**Snowdonia Aerospace Airspace Change Proposal
Design Options Development (Stage 2A), ACP-2019-58
Llanbedr Danger Area (DA) – Version 3**

This report documents the “Stage 2A Options Development” element of the Snowdonia Aerospace LLP submission for an Airspace Change Proposal, Reference: ACP-2019-58, Llanbedr Danger Area (DA), under the Civil Aviation Authority (CAA) CAP1616 Airspace Change Process.

Figure 4 – Draft airspace design Option #1 for ACP-2019-58, Llanbedr Danger Area (DA)

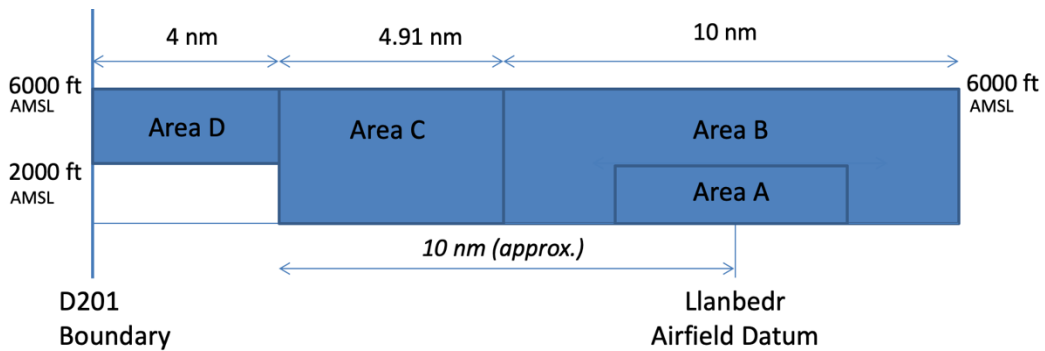
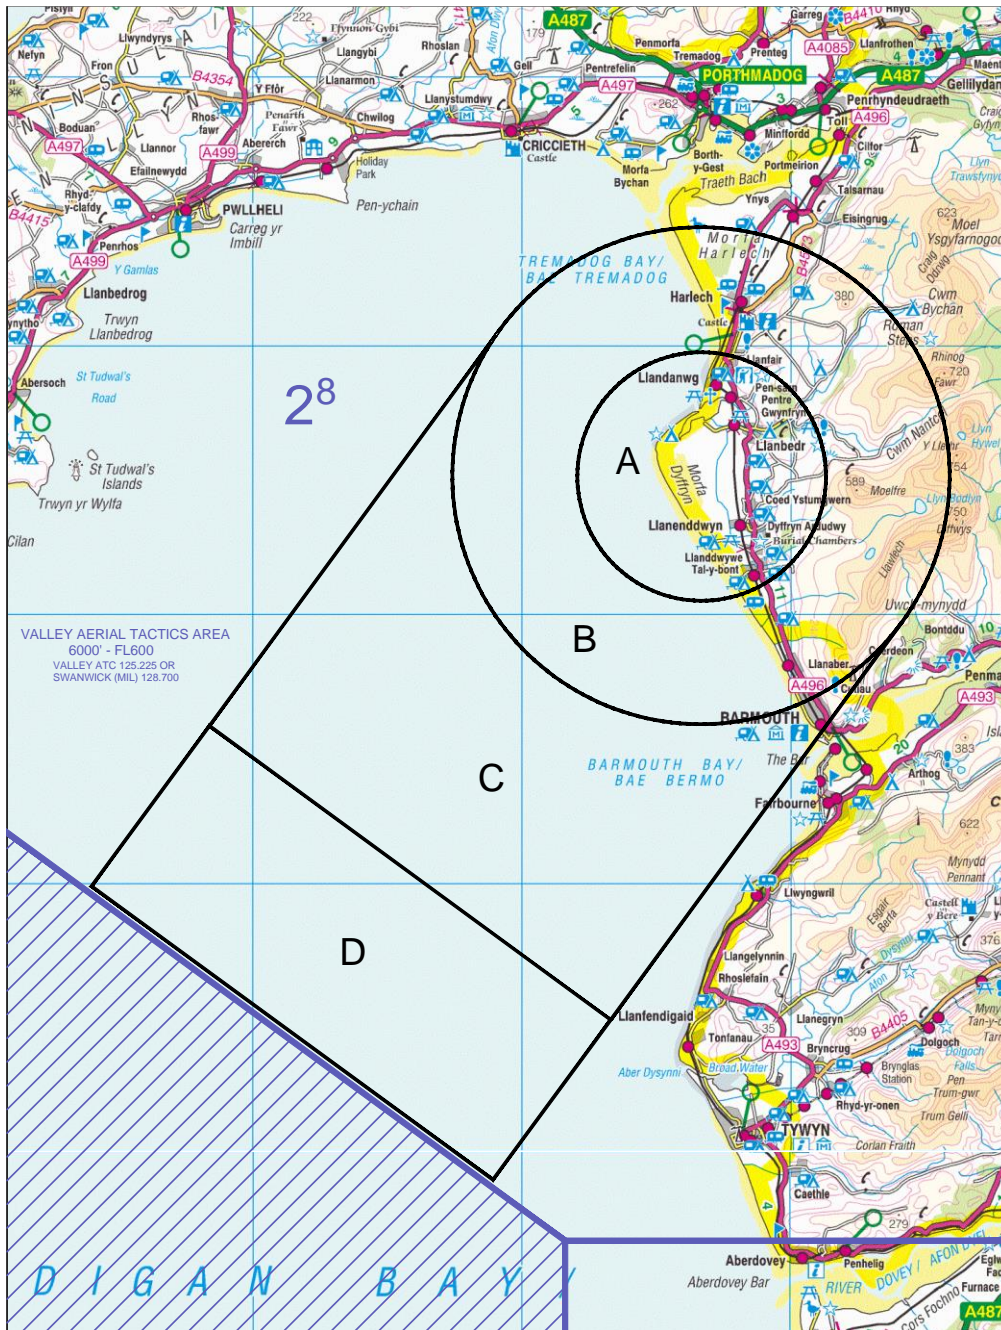
24	Option 1 offers the greatest operational flexibility to afford SAC / Spaceport Snowdonia the potential to become the UK's leading test and launch facility for the advancement of Space and	Email (see Annex 1)	RDT&E objectives	1	<p>Discussion: Noted preference for Option #1. A 6000ft upper height limit has been identified to enable small-scale rocketry over the aerodrome and provide a more flexible transit corridor for larger vehicles to gain access to D201 for other launch activities</p>

Figure 5 – Draft airspace design Option #2 for ACP-2019-58, Llanbedr Danger Area (DA)

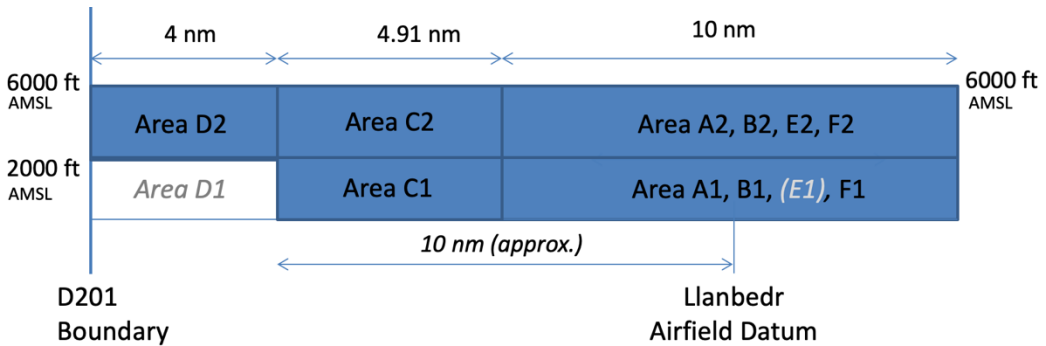
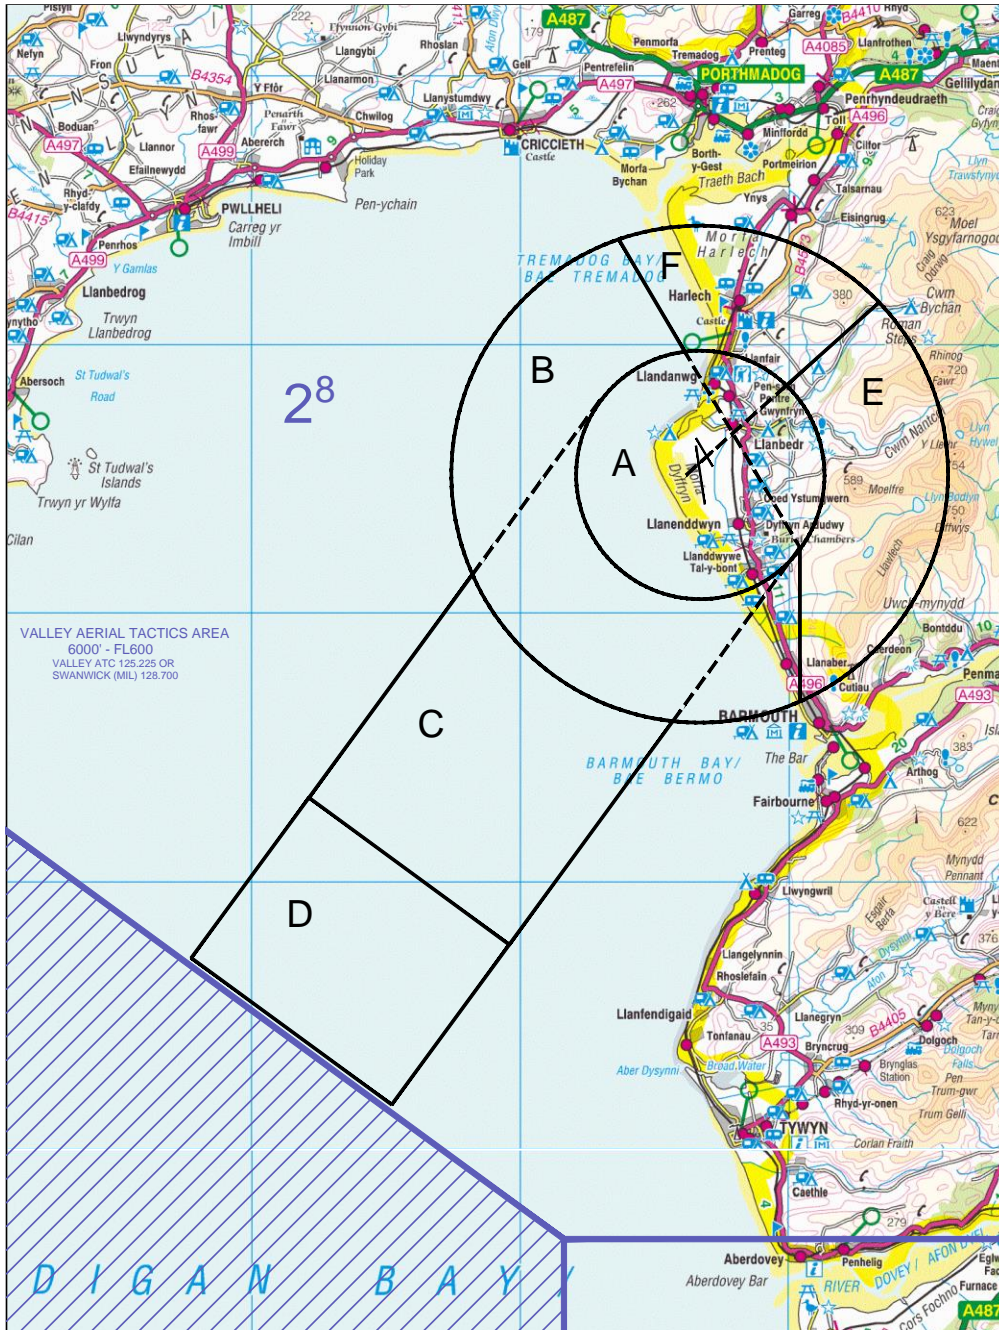
15	Option two. I have concerns regarding low level UAV operations in areas A-F. <i>[Option #2 creates a further sub-division below 2000ft]</i>	Email (see Annex 1)	Safety	2	<p>Discussion: We expect twice as many flights below 2000ft as above because the effect to be delivered by small/light drones (our typical customers) is inherently low-level in nature. All flight operations in the DA will be subject to a separate safety case to be reviewed by the CAA and additional action will be taken if required.</p>

Conclusion: The current Design Options satisfactorily address this point in full.
16	Our main concern is the draft proposal for an area of inland airspace over one of the most tranquil parts of the National Park (Area E) to be used as ‘an extended area for upland/mountain operational testing’. We request that draft Danger Area proposals are reconsidered in order to avoid significant harm to public enjoyment of the special qualities of this part of the National Park.	Email (see Annex 1)	Over-land operation, environmental protection	1 & 2	<p>Discussion: The shape of the Danger Area (DA) has been designed to be simple to interpret and implement. This means that whilst specific geographic locations may nominally sit within the DA, operating procedures will be put in place to ensure any drone flying activities are kept clear of sensitive areas. We have made a forecast of future business and anticipate that we will need to activate the DA on approximately 100 days per year, but that the vast majority of operations (approximately 90%) will be over the aerodrome or out over the sea. We believe the combination of limited over-land drone operations (less than 10 days a year), low noise footprint, operating procedures, geo-fencing and CAA approval of the safety case will assuage stakeholder concerns. Furthermore, we will seek to negotiate Letters of Agreement (LOA) with key stakeholders regarding areas, hours of operation <i>etc</i>.</p> <p>Conclusion: The current Design Options are considered to be fully compatible with local community wishes whilst also meeting other stakeholder requirements, but continued community engagement is needed to further refine the details and operating procedures that will inform a Letter of Agreement (LOA).</p>

17	Both designs only leave a small portion of Glass G airspace (4nm wide) to transit underneath the proposed DA.	Email (see Annex 1)	Safety	1 & 2	Discussion: The 4nm “tunnel” is a feature of the Temporary Danger Area (TDA) that was arrived at after previous consultation with stakeholders, and we have decided to promulgate the same design feature as part of the permanent Danger Area design options, but we remain open to considering alternative suggestions and would welcome
